Justice Center Program Description

Re: Fort Bend County Justice Center
Rosenburg, Texas

Attached, please find our Final GMP pricing for providing construction services for the new Fort Bend County Justice Center, connector tunnel to the jail, and related site improvements. Our GMP is based on the Final GMP documents, dated March 30, 2009 as provided by PGAL Architects.

SCHEMATIC COOLING TOWER FRAMING

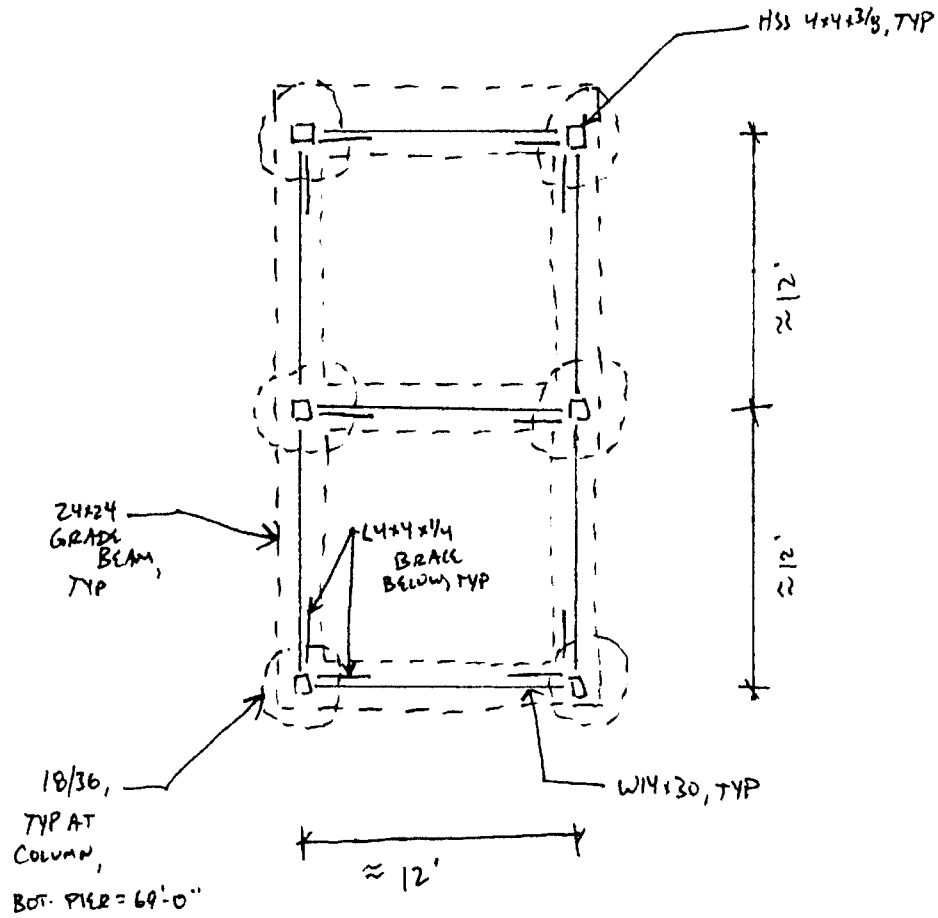
- ALL STEEL TO BE HOT-DIP GALVANIZED
- FOUNDATIONS TO BE COORDINATED SO AS NOT TO CONFLICT WITH RETAINING WALL FOUNDATIONS
